**California Traffic Control Devices Committee (CTCDC)
Agenda Item Report**

Meeting Date: May 7, 2026 Item Number: 26-04	From: Kathryn Kleinschmidt, Caltrans
Sponsored By: Devang Vora, Caltrans	Presented By: Kathryn Kleinschmidt, Caltrans
Description: Caltrans District 5 requests CTCDC approval for a new word message sign "COUNTY FIRE STATION"

Attachment A – Proposed New Sections in 2I.03

Add County Fire Station Signs (SG38B (CA) and SG39B (CA))

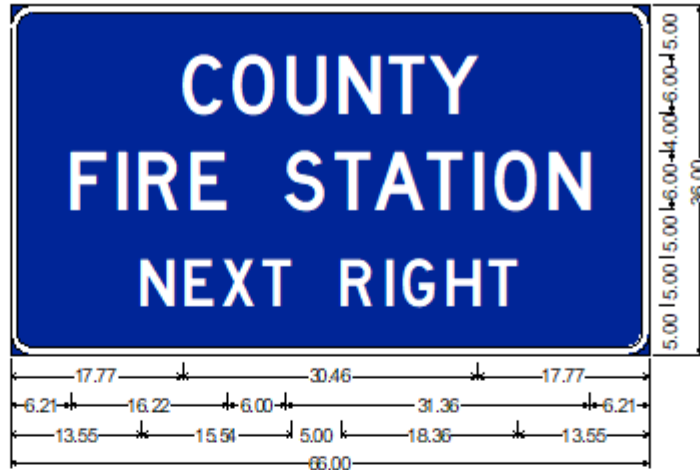
⁷⁸ The COUNTY FIRE STATION NEXT RIGHT (SG38B(CA)) sign may be used on freeways in rural areas to give advance notice of an exit to a County Fire Station which is within 0.5 miles of the exit and is open 24 hours each day of the year. These signs are to be furnished and installed "at no cost to the State" through an encroachment permit.

⁷⁹ The COUNTY FIRE STATION with Arrow (SG39B(CA)) sign may be used in rural areas on expressways, conventional highways and freeway ramp terminals in advance of the turn off to a County Fire Station which is within 0.5 miles of the exit and is open 24 hours each day of the year. These signs are to be furnished and installed "at no cost to the State" through an encroachment permit.

Proposed SG38B(CA) Sign:

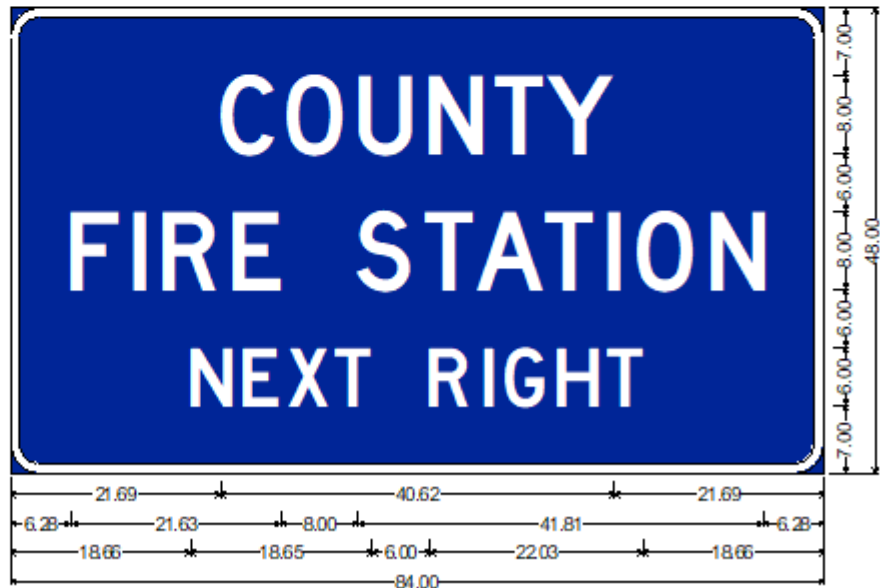
Conventional Road:

SG38B(CA);
2.25" Radius, 0.75" Border, White on Blue;
"COUNTY", D; "FIRE STATION", D; "NEXT RIGHT", D;

Freeway / Expressway:

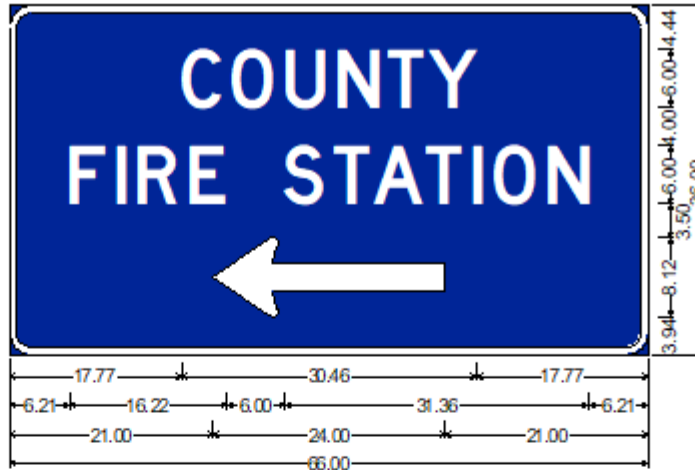
SG38B(CA);
3.00" Radius, 1.00" Border, White on Blue;
"COUNTY", D; "FIRE STATION", D; "NEXT RIGHT", D;

Proposed SG39B(CA) Sign:

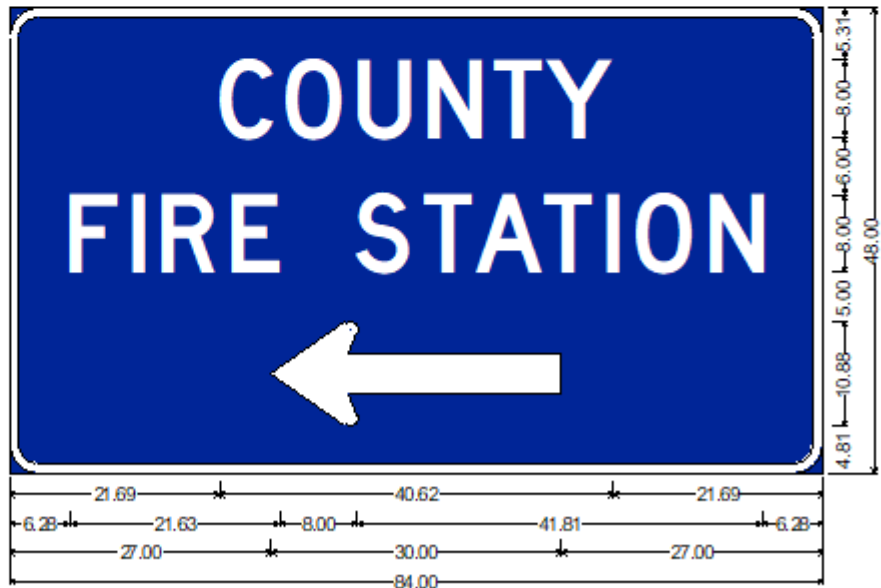
Conventional Road:

SG39B(CA);
2.25" Radius, 0.75" Border, White on Blue;
"COUNTY", D; "FIRE STATION", D;
Standard Arrow Custom 21.00" X 8.13" 180°;

Freeway / Expressway:

SG39B(CA);
3.00" Radius, 1.00" Border, White on Blue;
"COUNTY", D; "FIRE STATION", D; Standard Arrow Custom 30.00" X 10.88" 180°;
